PLANNING AUTHORITY COMMITTEE - 11 OCTOBER 2021 ATTACHMENTS

| <b>4.1 PA2021.0125 - 139 WAVERLEY ROAD DON - 2 LOT SUBDIVISION.....</b>                             | <b>4</b>  |
| <b>4.1.2 REPRESENTATION - TINA SMITH - PA2021.0125 - 139 WAVERLEY ROAD - 2 LOT SUBDIVISION.....</b> | <b>88</b> |

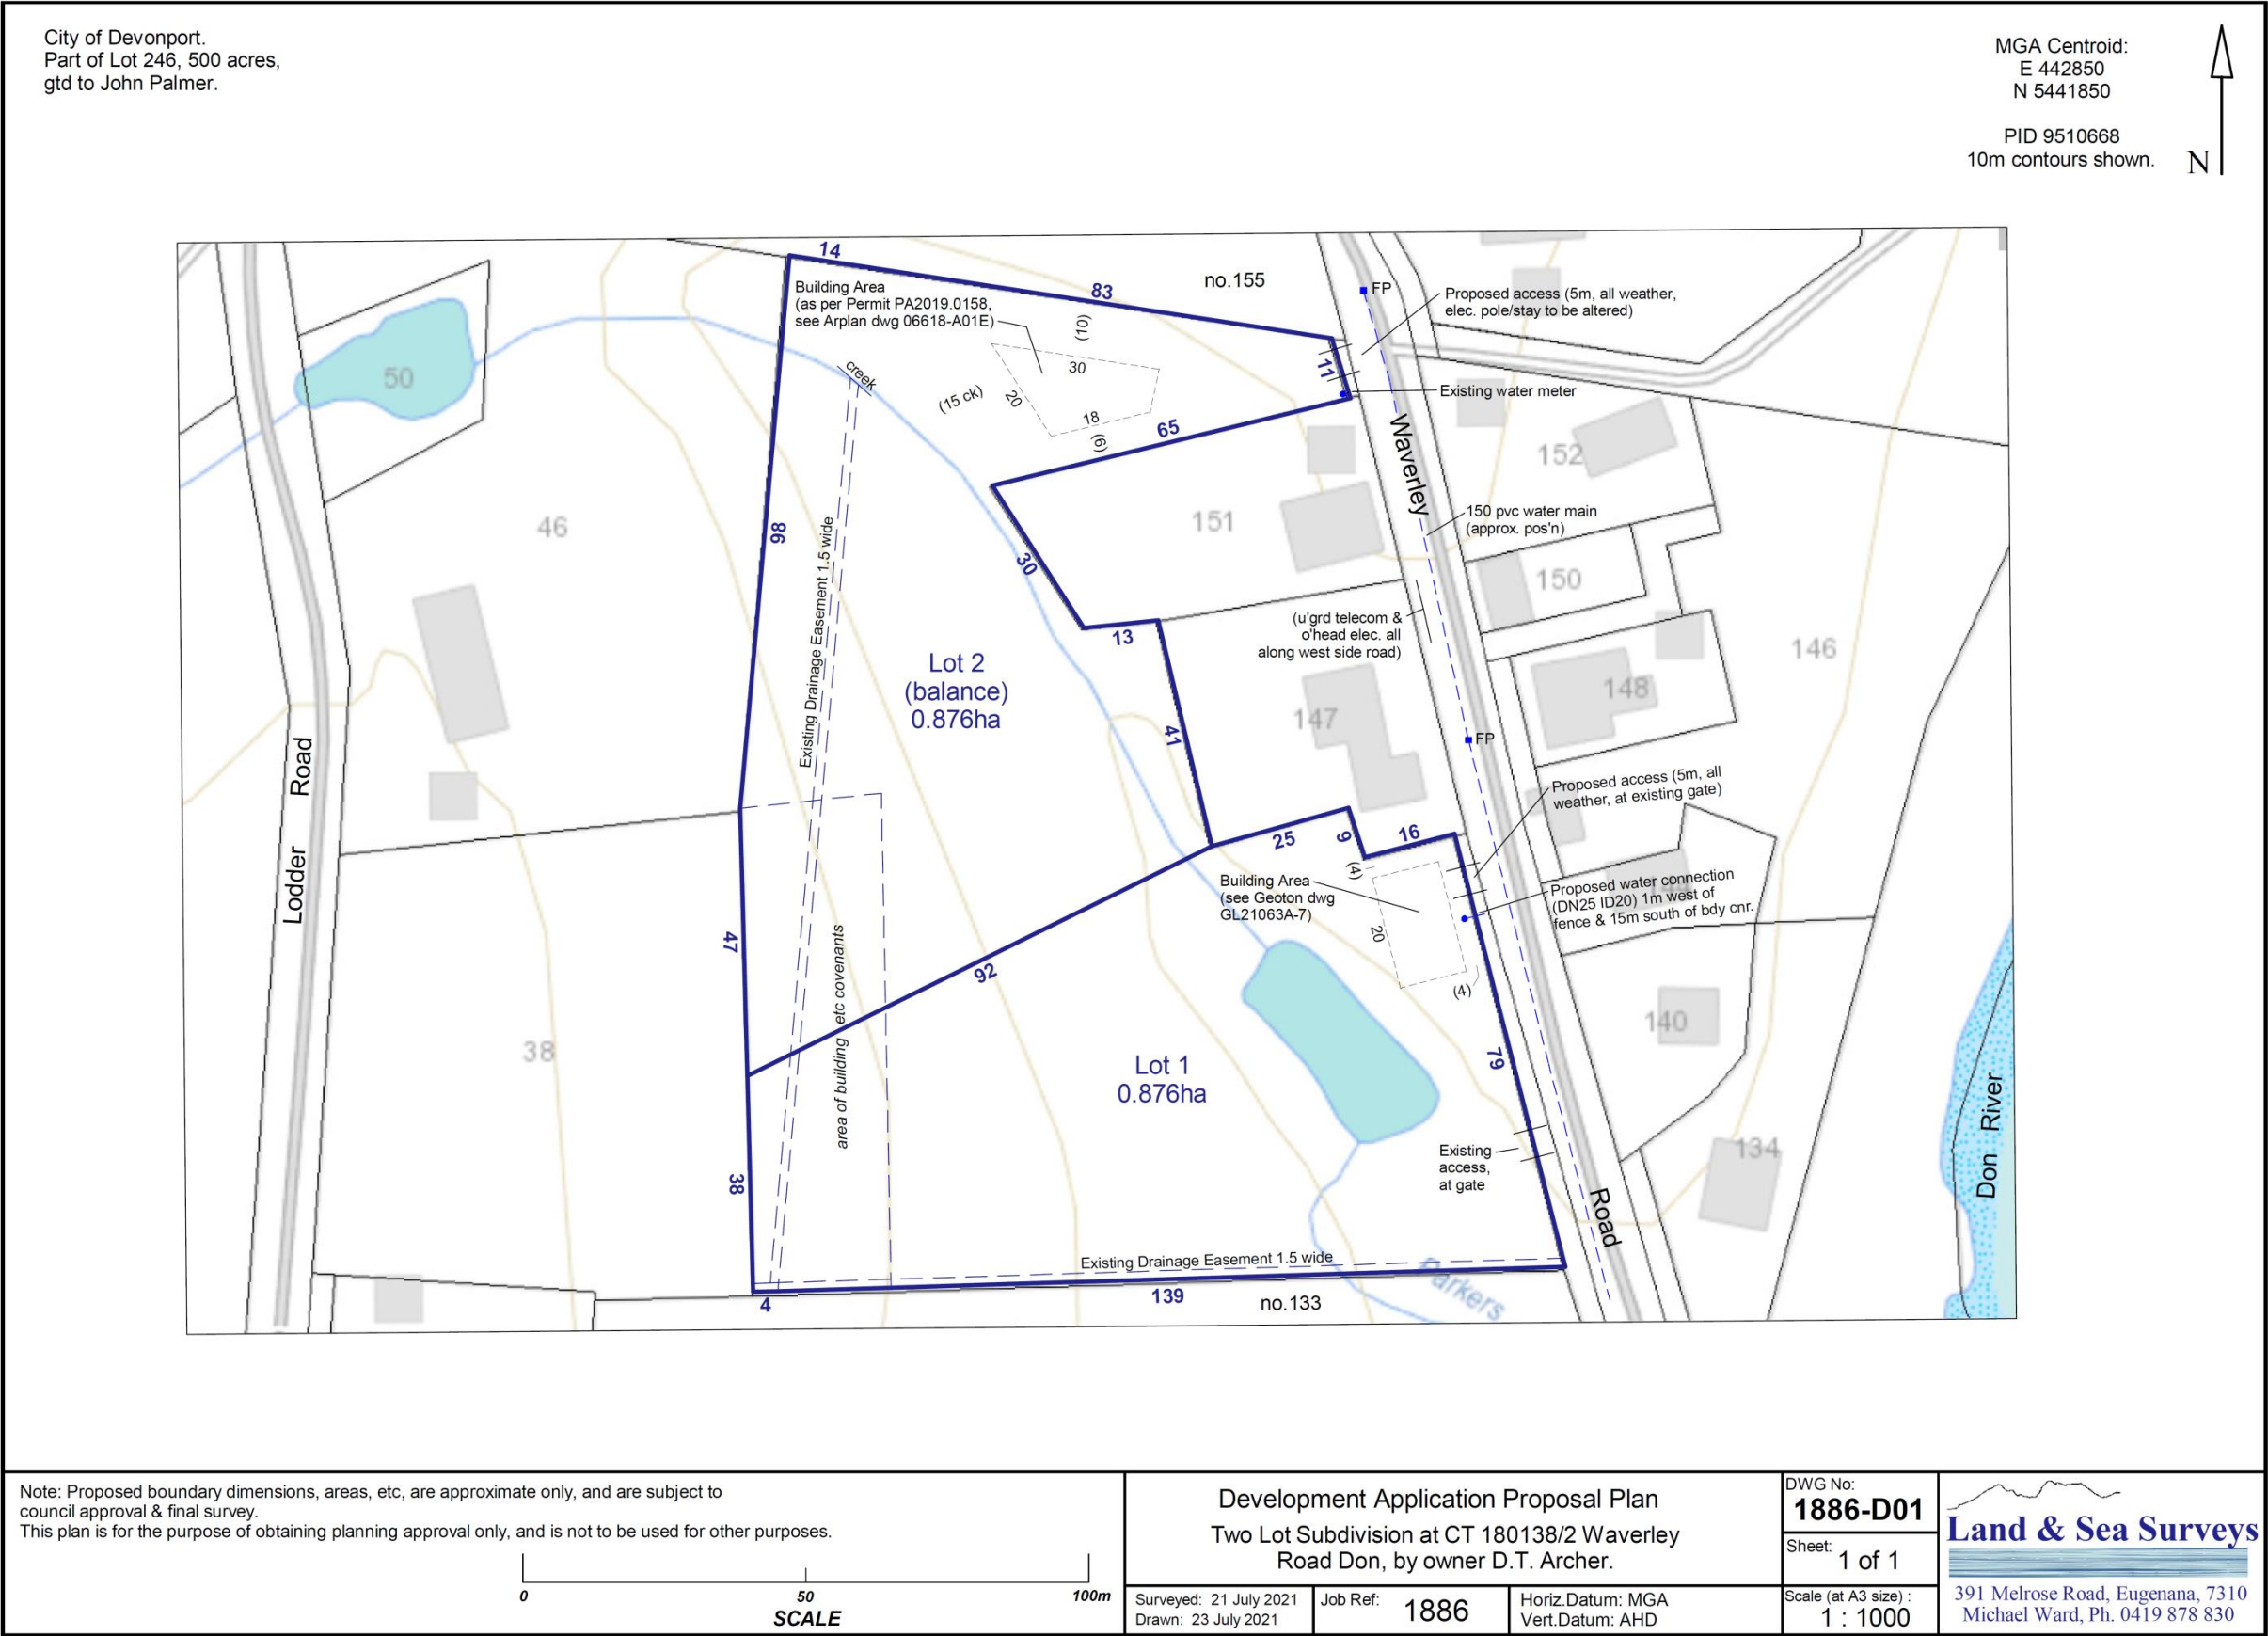
The Bushfire Hazard Management Plan supplied by ES&D that accompanies the application clearly shows a Bushfire Hazard Management Area within a Waterway and Coastal Protection area (Appendix B). C7.7.1 clearly states that all buildings and any associated bushfire hazard management areas must be outside a Waterway and Coastal Protection area, both of which this proposal fails to do. Whilst much of the vegetation on this section of the land has recently been cleared, the works associated with subdivision and subsequent clearing to meet the Bushfire Hazard Management Area will also impact on the priority vegetation area (Appendix C). I do not believe this development meets either the acceptable solutions or performance criteria in C7.6.2. Hence, the Bushfire Hazard Management Plan accompanying this application must be considered invalid.

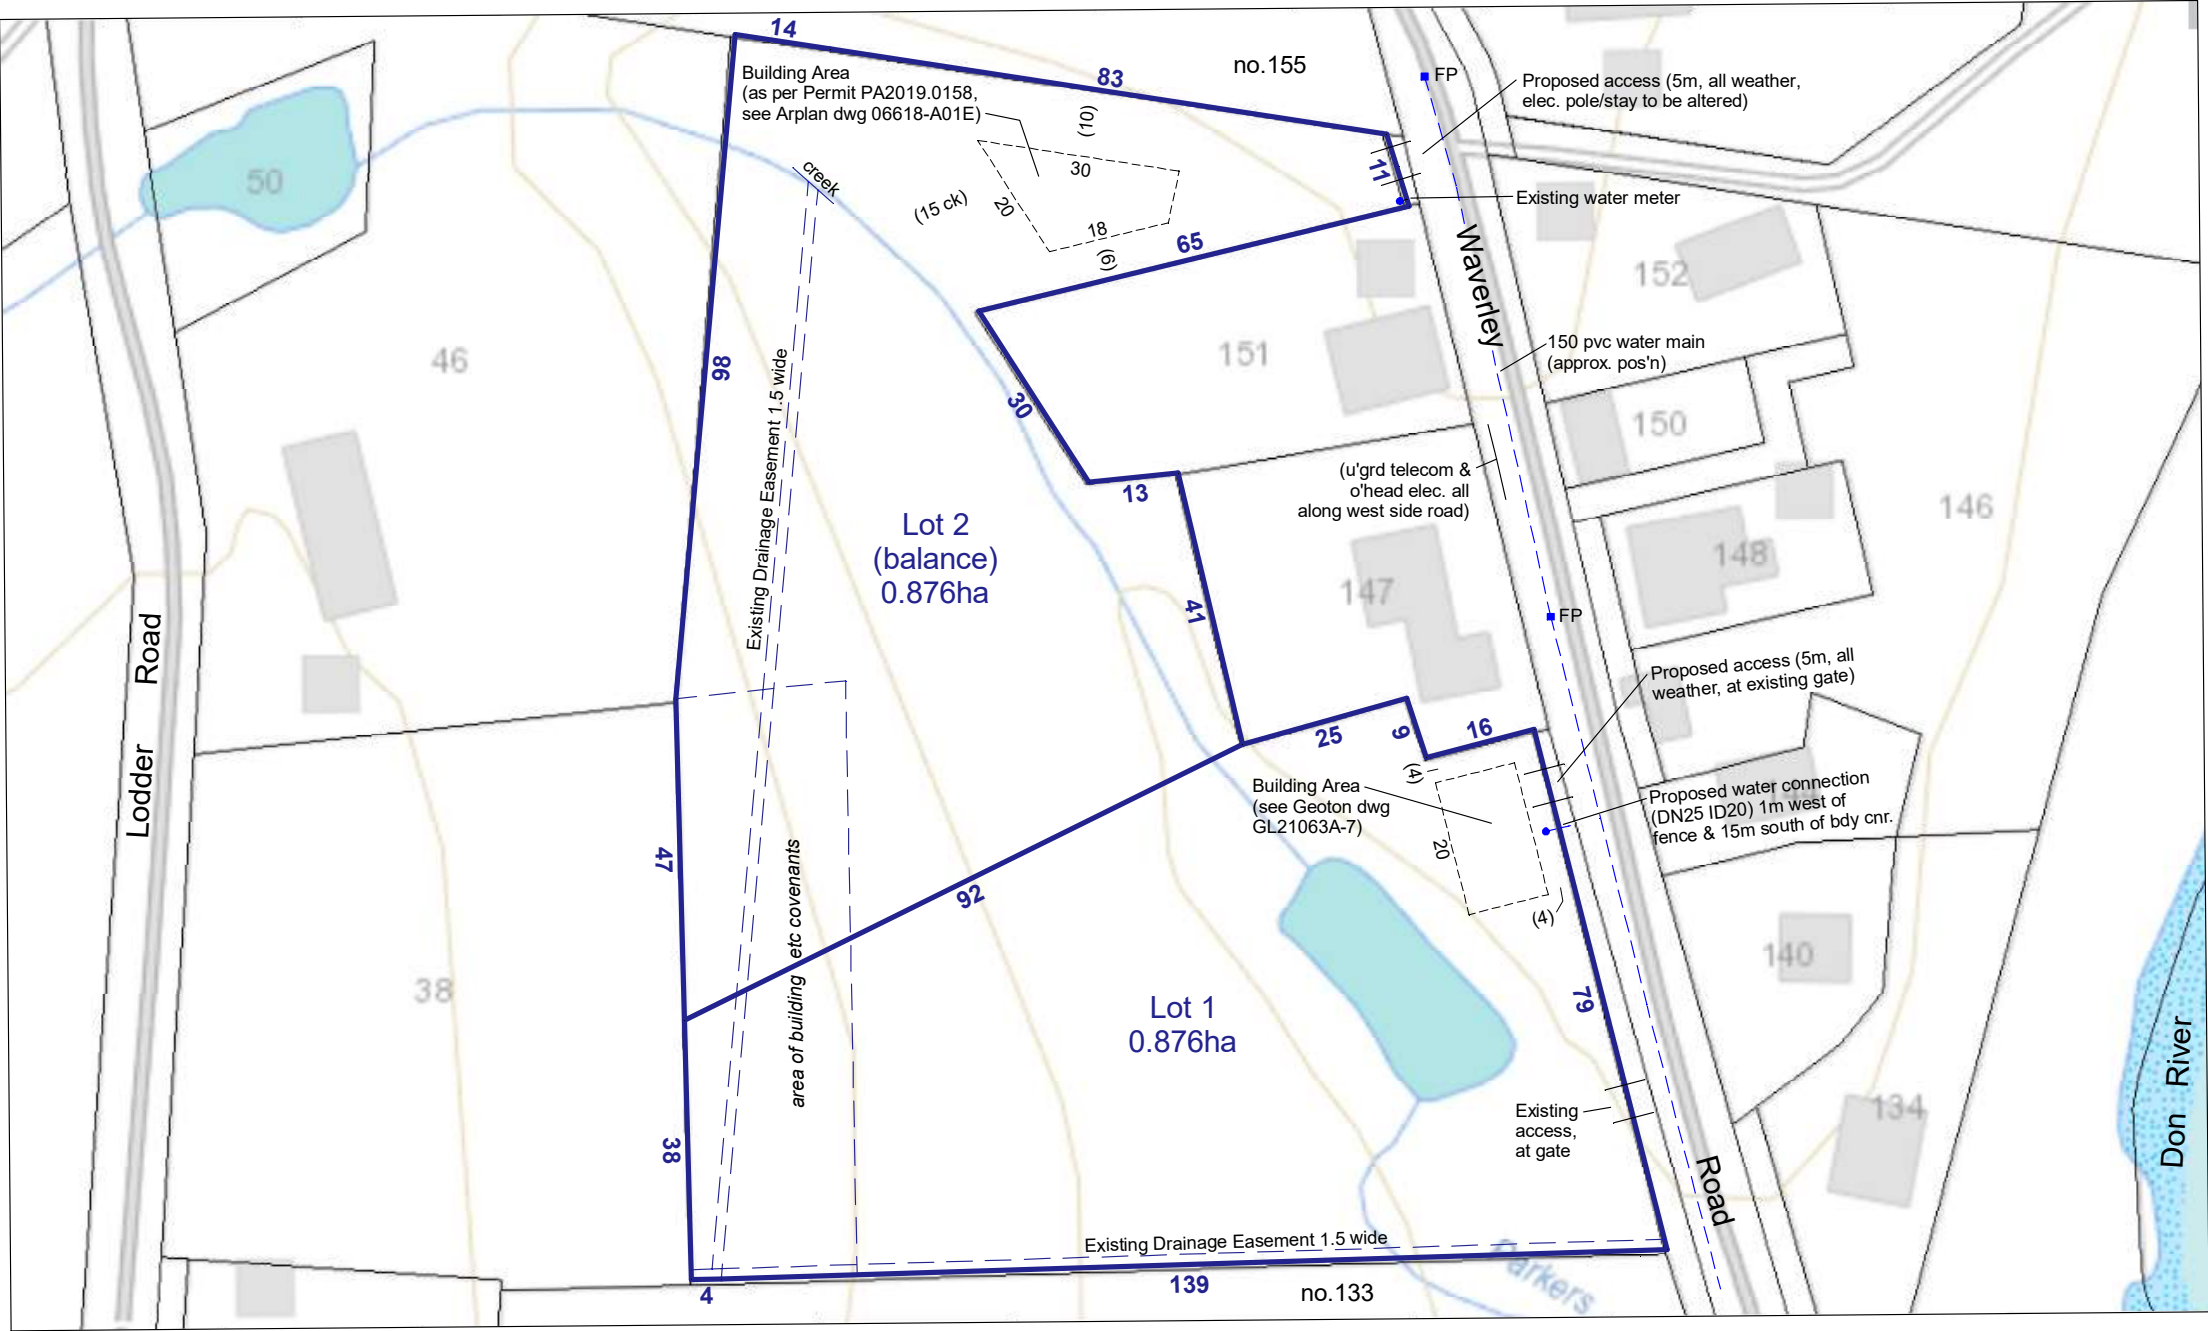
The entire location of the Aerated Wastewater Treatment System specified and shown by Geoton on their site plan, Figure 7, falls within the Waterway and Coastal Protection Area. It would be fair to assume that if provision for a wastewater system cannot be outside a designated waterway this development has no grounds to be approved. Geoton has also clearly stated in their report on p.12 that the minimum setback of the on-site wastewater management system is 15m from downslope sensitive features such as watercourses. If this is the case, it is rather ironic that they are happy to show on plan the location of the proposed AWTs within the 15m radius of the dam (Appendix 1).
